AMENDED/ADDITIONAL PLANS (FOR CURRENT DEVELOPMENT APPLICATIONS)

26-62 Bridge Road, Belmore - DA-519/2013

CANTERBURY LEAGUE CLUB, 26 BRIDGE ROAD, BELMORE NSW 2192
DA 519/2013 – SECTION 96/A

DA/SECTION 96 SHADOW
 COMPARISON - HOURLY 9AM - 3PM
 21 JUNE - SHEET 2

SECTIONS
SHEET 1

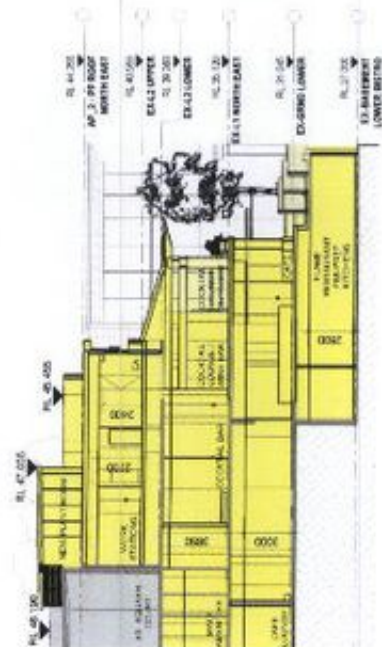
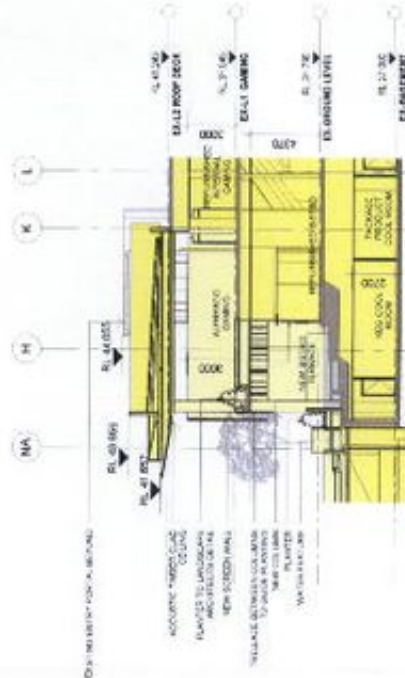
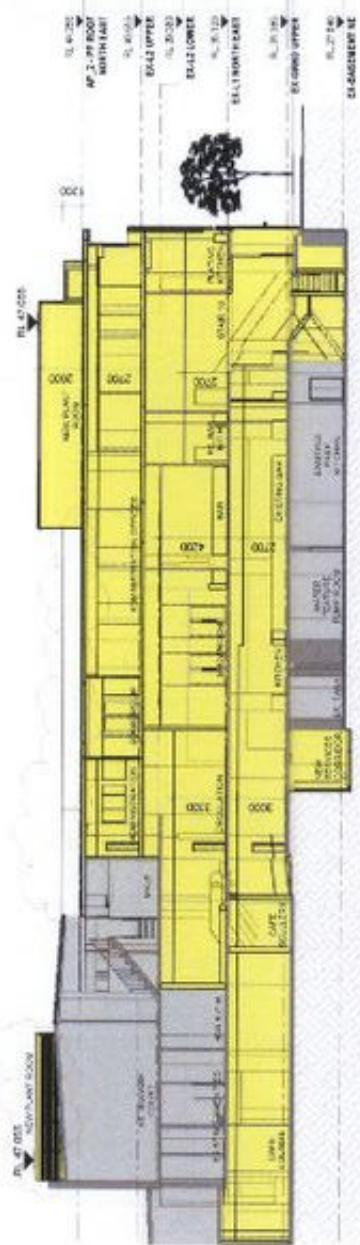
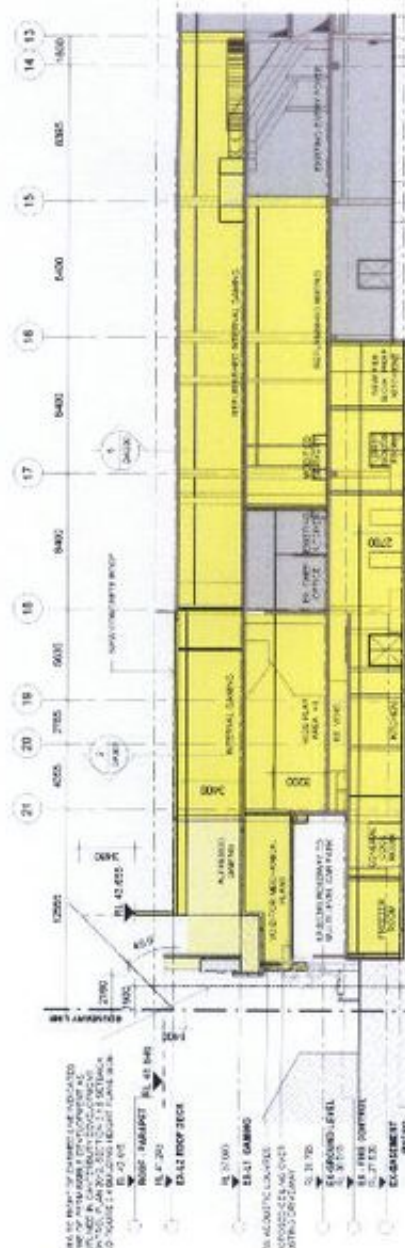
We have also attached a revised Section 96 drawing Nos. DA119/3 (roof plan), DA210/3 (external elevations) and DA300/4 (sections sheet 1). These drawings indicate a relocation of a plant room which was shown almost adjacent to its new position. This has been necessary due to the staging of the project. If you have any further queries on this please give me a call. We have attached four copies of these plans for your information and attention.

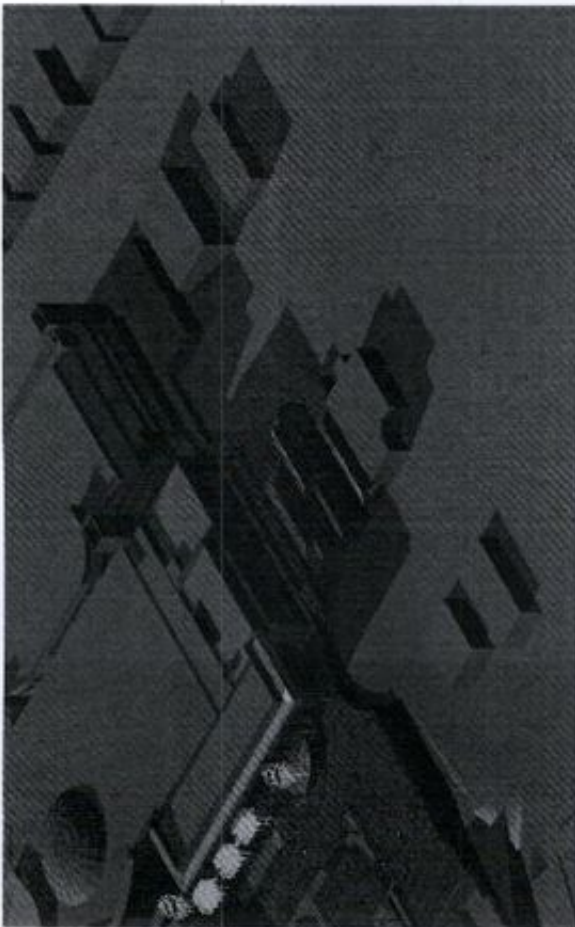
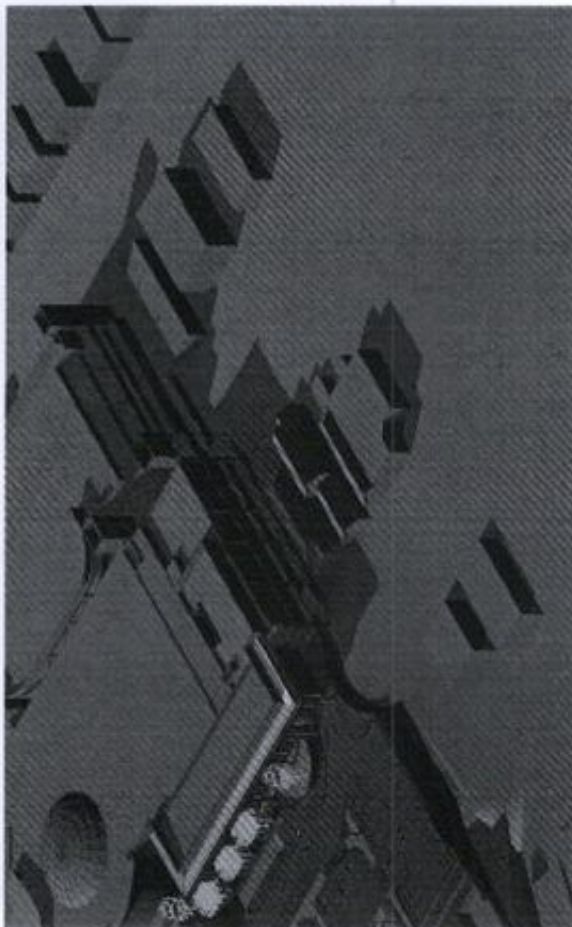
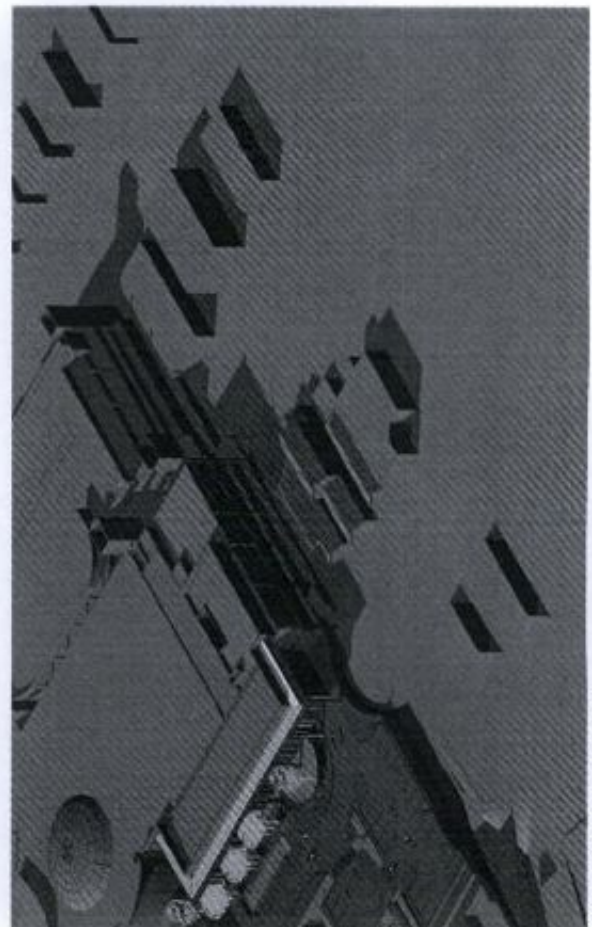
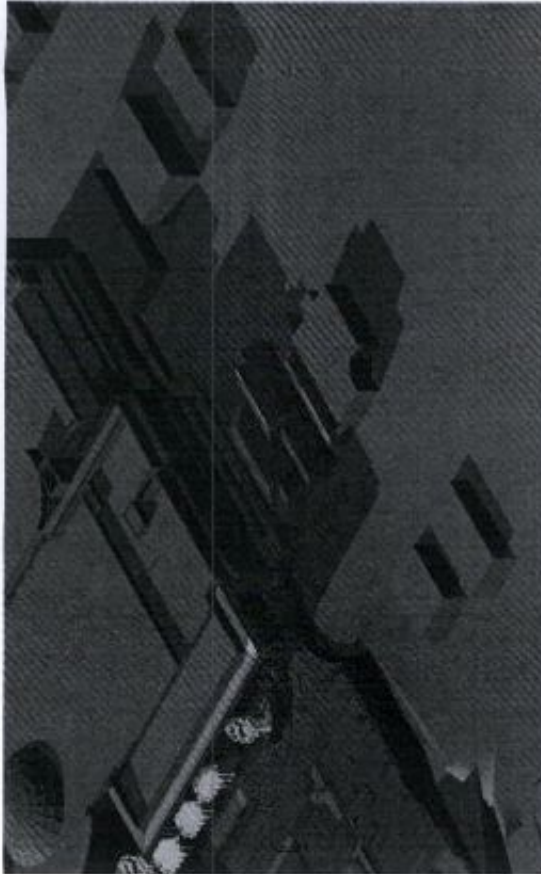
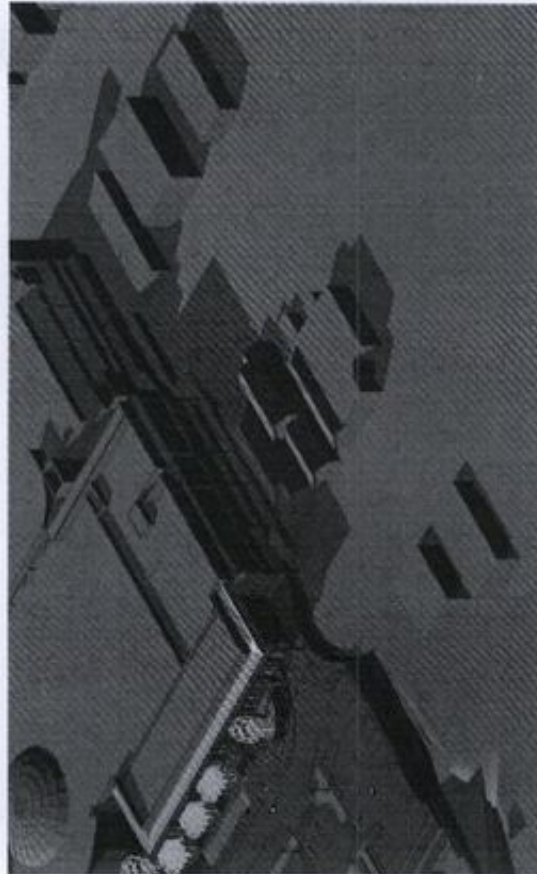
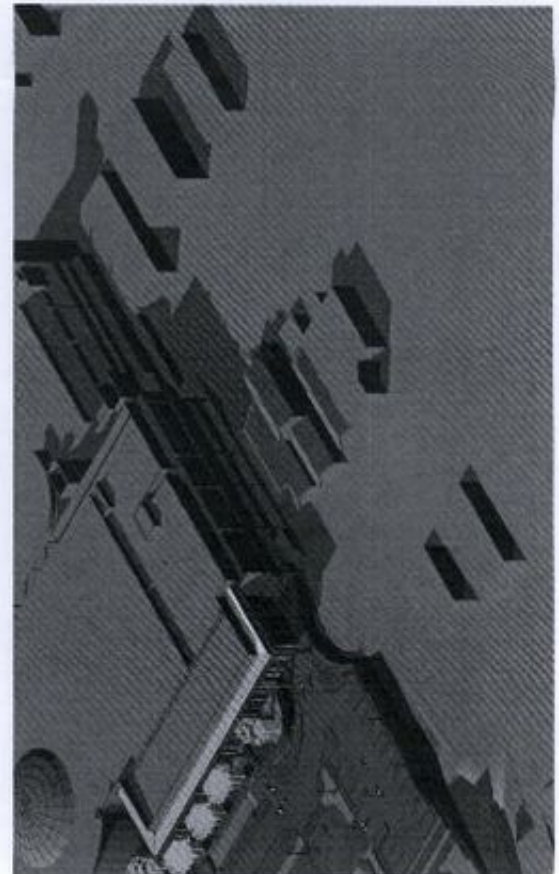
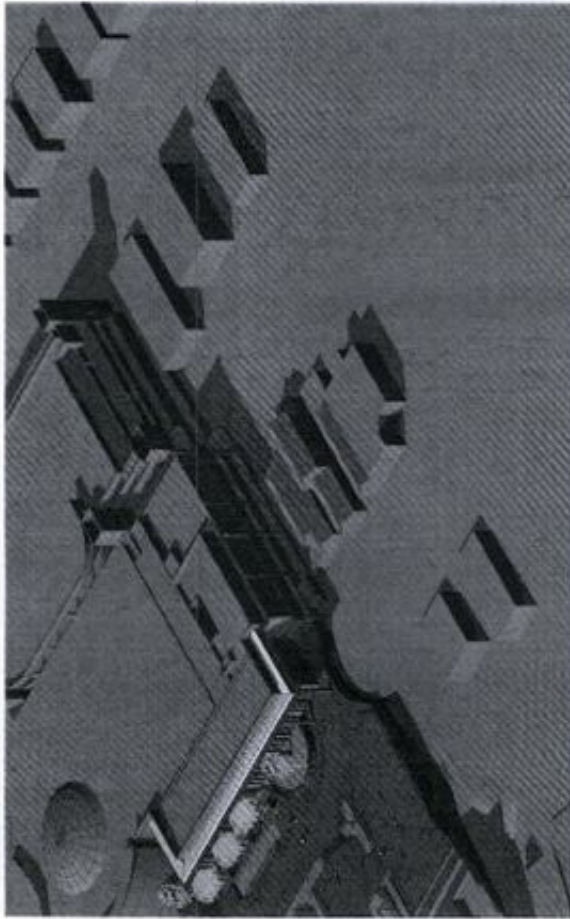
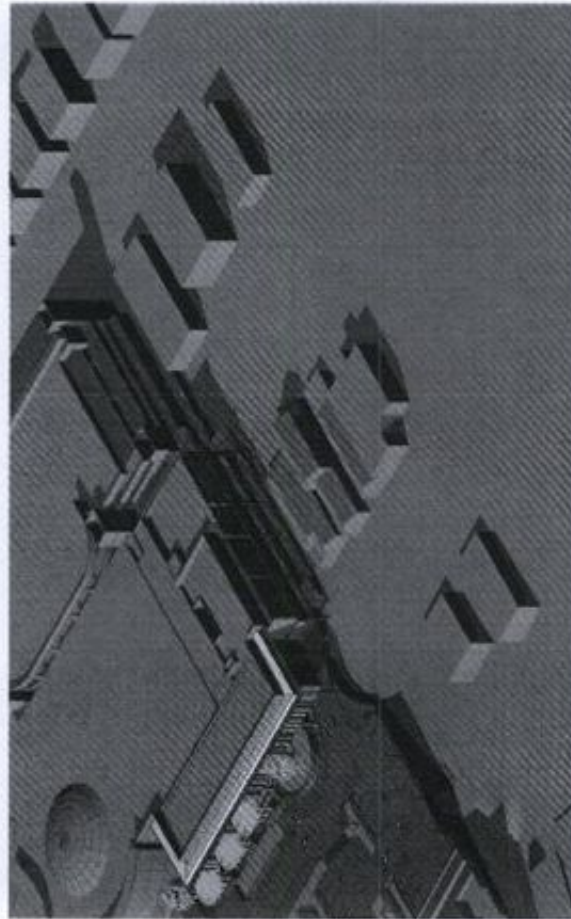
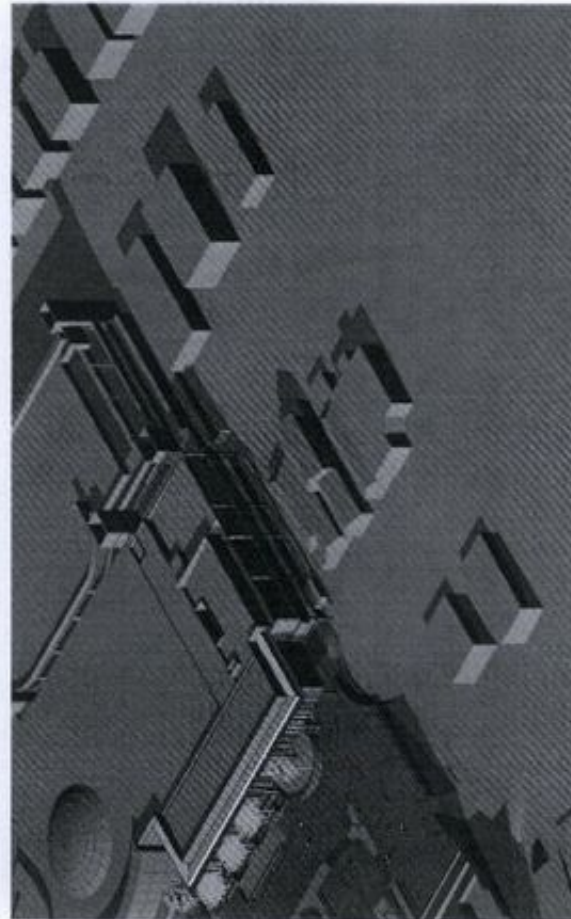
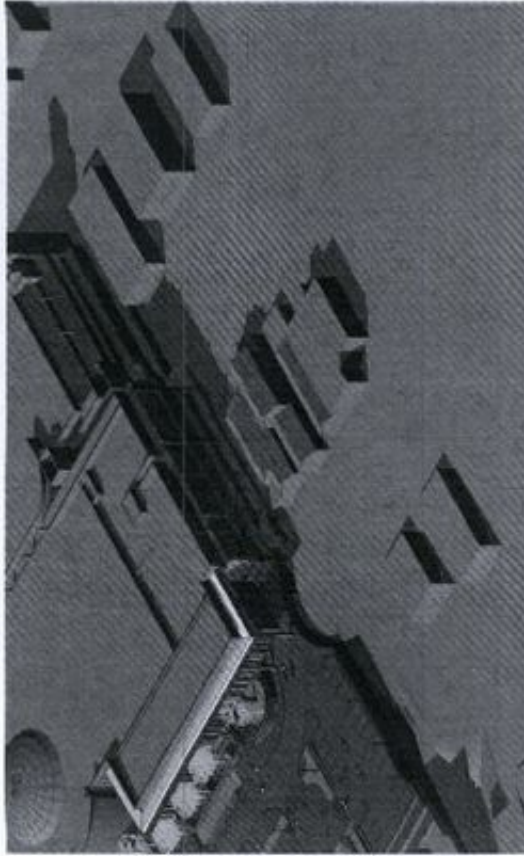
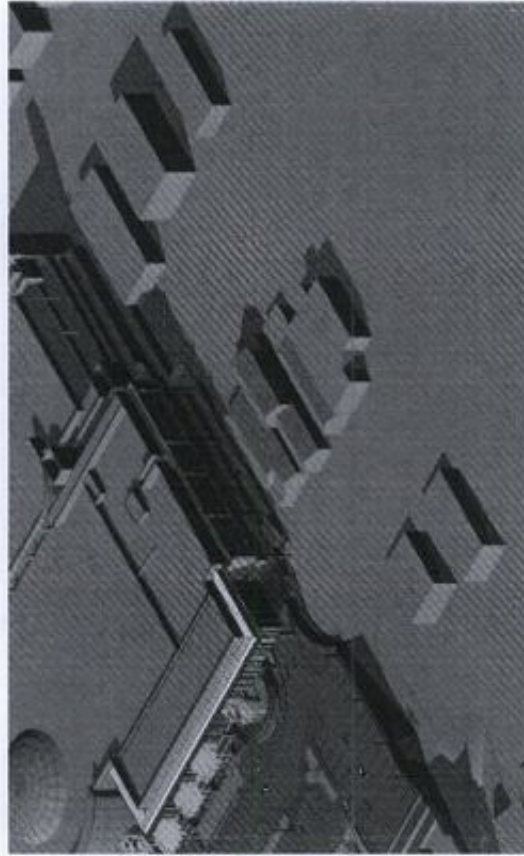
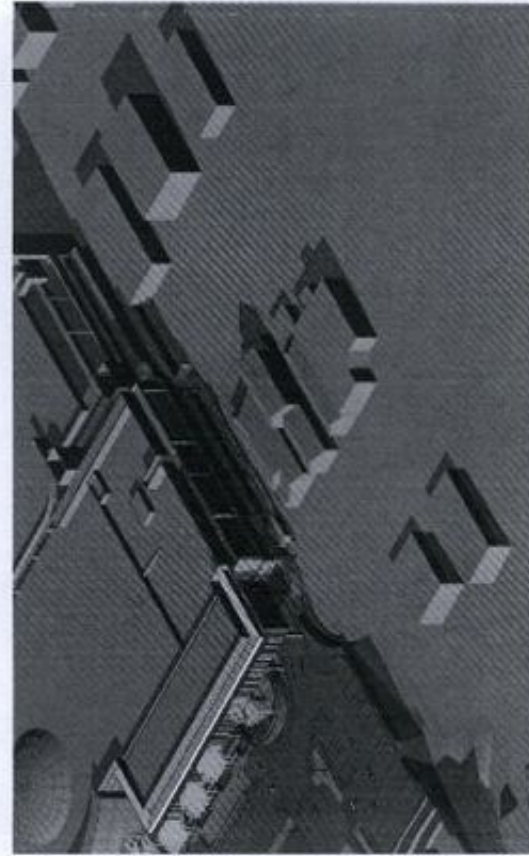
"It is advised that you re-consider the changes proposed along the western elevation where the Level1 plant room is proposed to increase in overall wall height. It is required that you either maintain this part of the development as approved under Development Consent DA-519/2013, or provide additional detailed analysis of the shadowing impacts and clearer diagrams at hourly intervals for our assessment to demonstrate that the proposal is in keeping with the objectives and requirements under Part 6.2 of Canterbury Development Control Plan 2012."

This letter should be read with reference to the shadow analysis undertaken at hourly intervals by Altis Architecture (submitted under separate cover). The shadow analysis demonstrates the following:

- There will be negligible, if any, additional overshadowing to the backyard open space at 20, 22, 24 and 26 Gladstone Street at any time during the day. Further, all these properties receive good sunlight access to their front terrace area from 12.00pm onwards;
- There will be additional overshadowing of the backyard open space at 27 Collins Street between 11.00am and 1.00pm. Notwithstanding this, there will be good sunlight access to the backyard open space between 1.00pm and 3.00pm.

Please find attached the letter from Urbis which addresses this item. We have attached four copies of DA005/1 (one full size) which compares the overshadowing as at the original DA with the proposal of the section 96.
